**GENOA CHARTER TOWNSHIP
PLANNING COMMISSION PUBLIC HEARING
NOVEMBER 13, 2017
MONDAY
6:30 P.M.
AGENDA**

Attention:	Kelly Van Marter, AICP Planning Director and Assistant Township Manager
Subject:	Brighton Church of the Nazarene – Site Plan Amendment (Review #2)
Location:	7669 Brighton Road – northwest corner of Brighton and Aljoann Roads
Zoning:	SR Suburban Residential

Request to Amend the Approved Site Plan

DESIGNED BY: AEB
 DRAWN BY: AEB
 CHECKED BY:
 SCALE: 1" = 30'
 JOB NO. 17-329
 DATE 10-3-17
 SHEET NO. **C6**

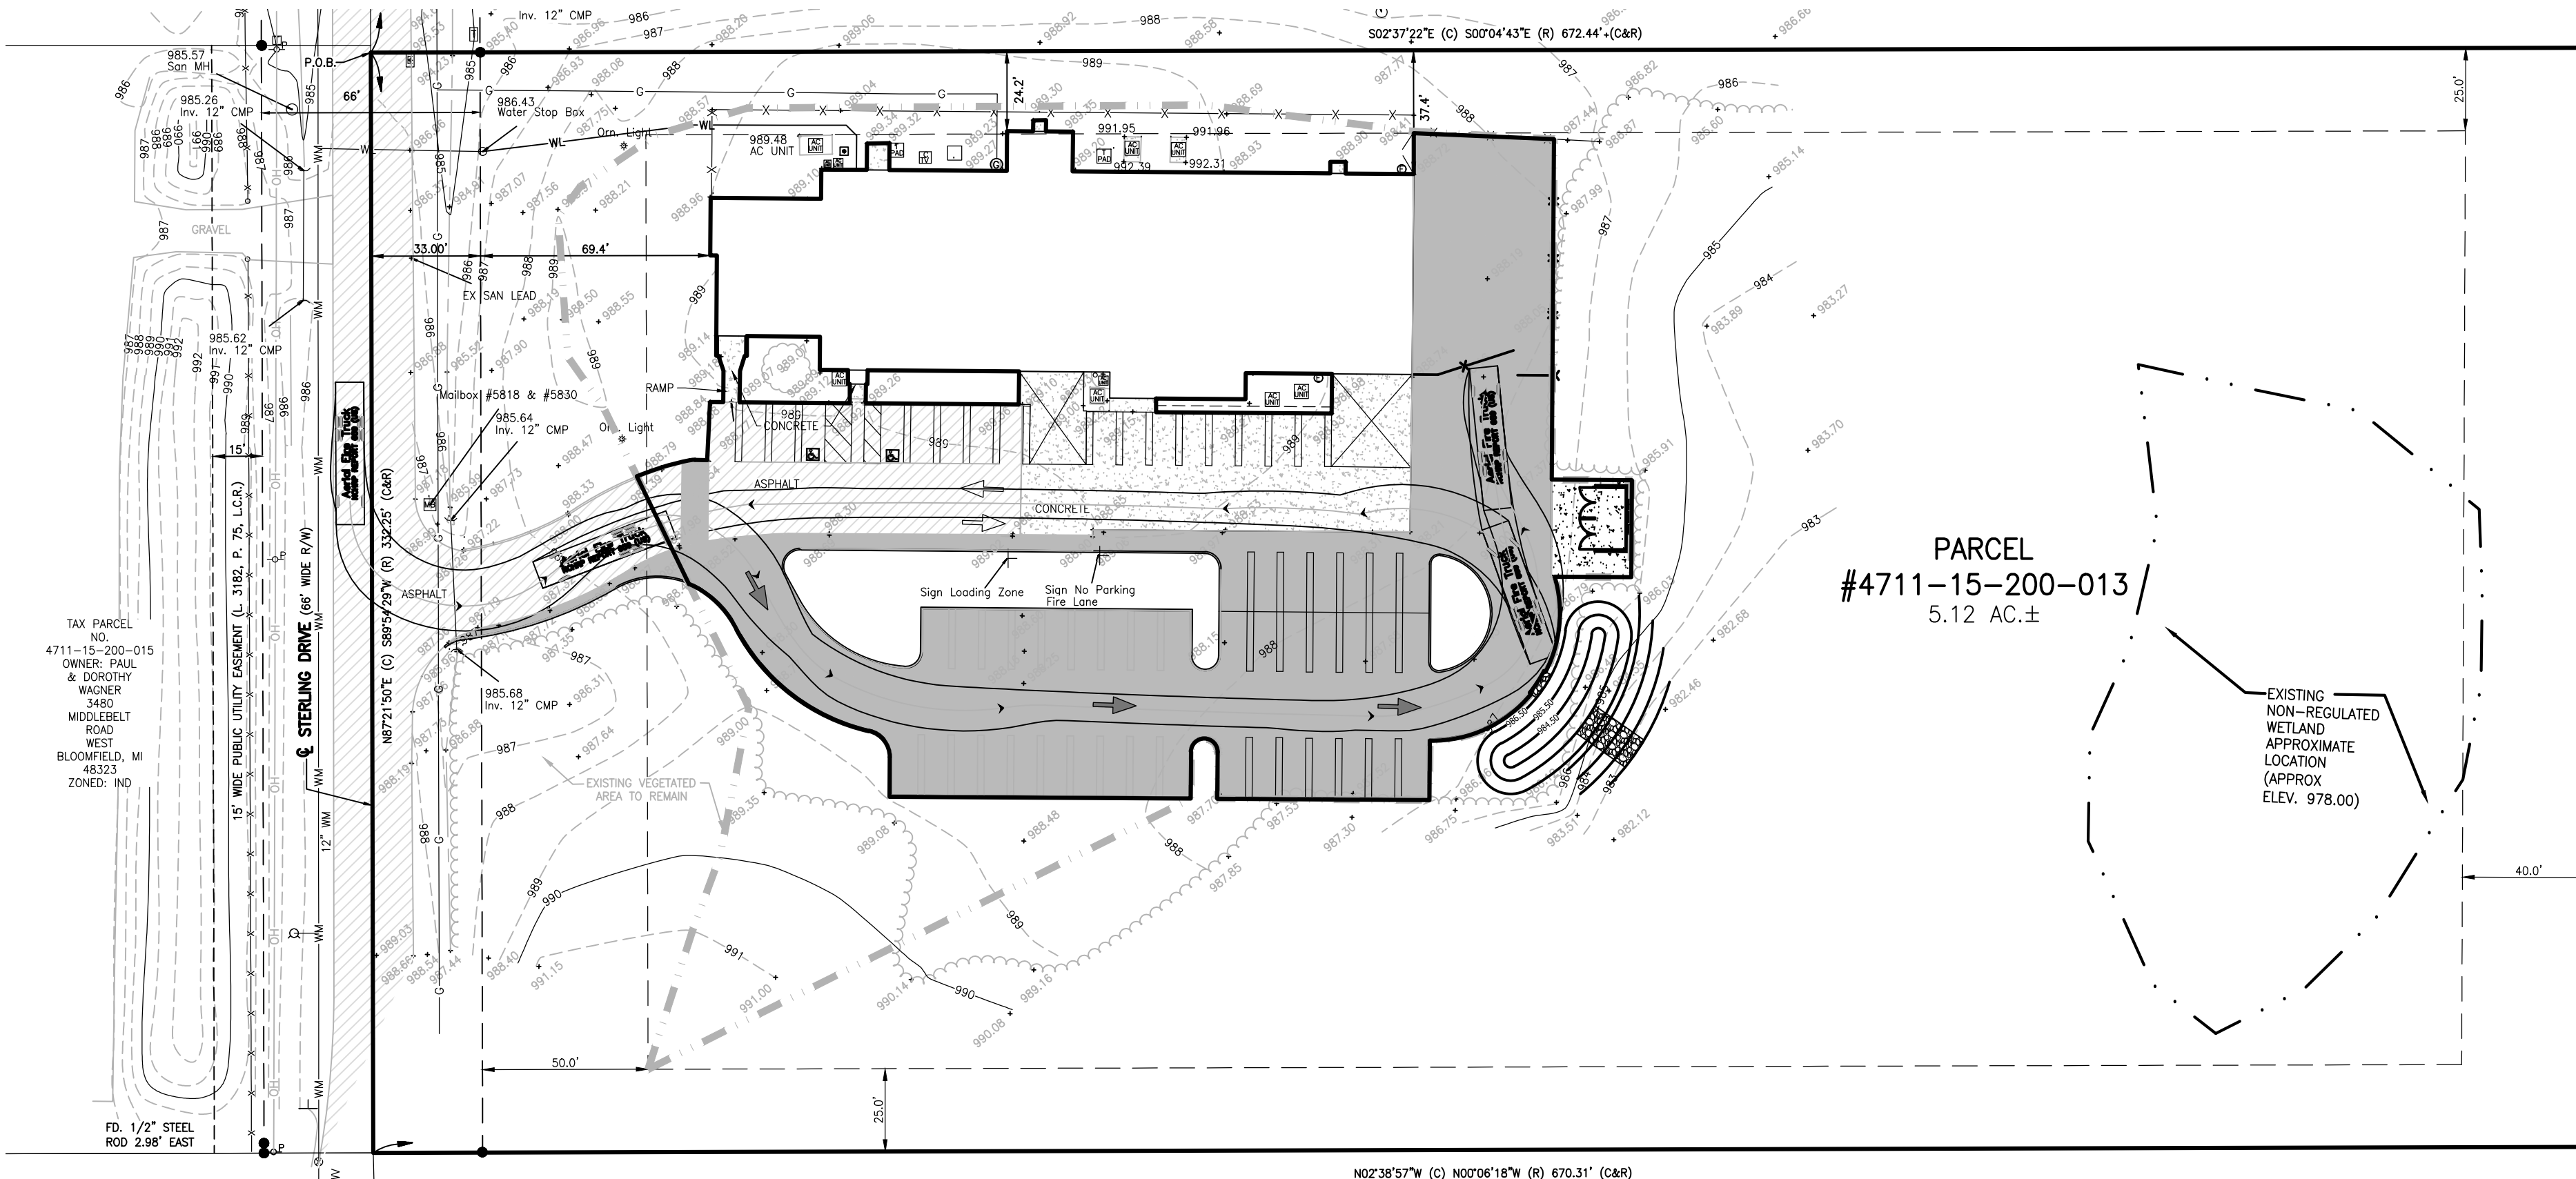
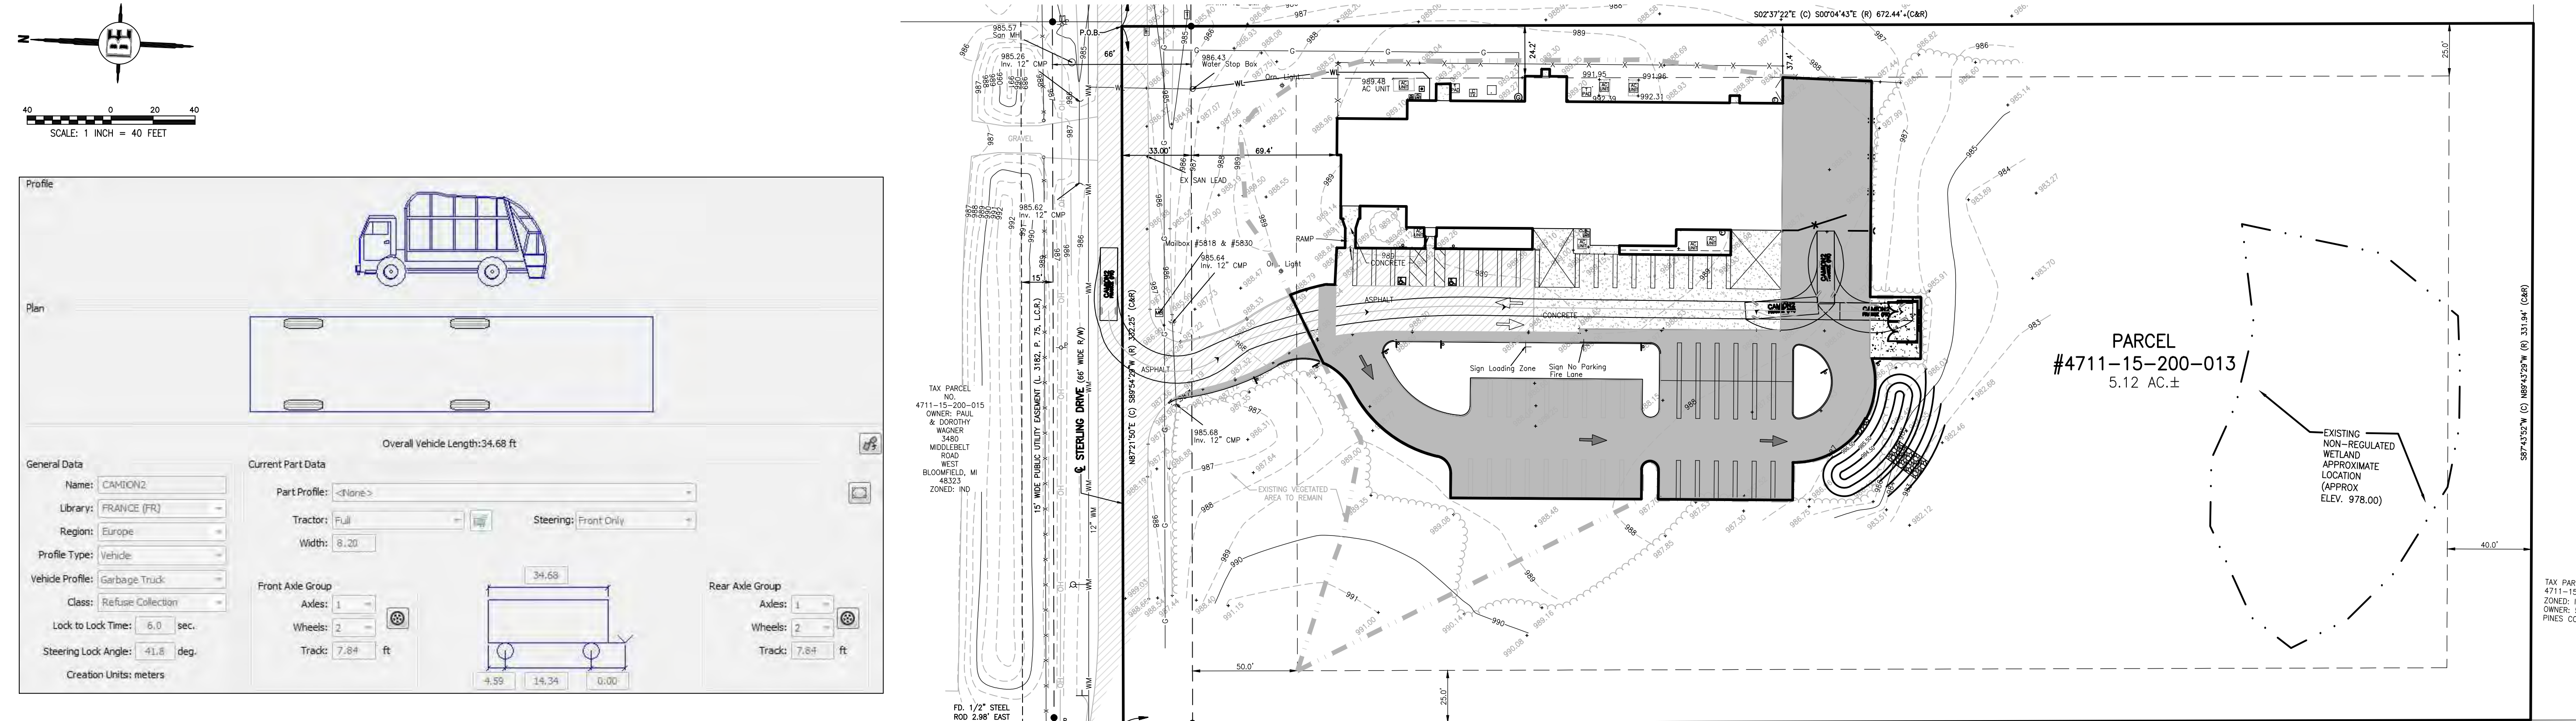
The site has existing vehicular access from Sterling Drive. Sheet C6 includes vehicle turning templates for refuse removal truck and a fire truck demonstrating that maneuvering will be accommodated on-site.
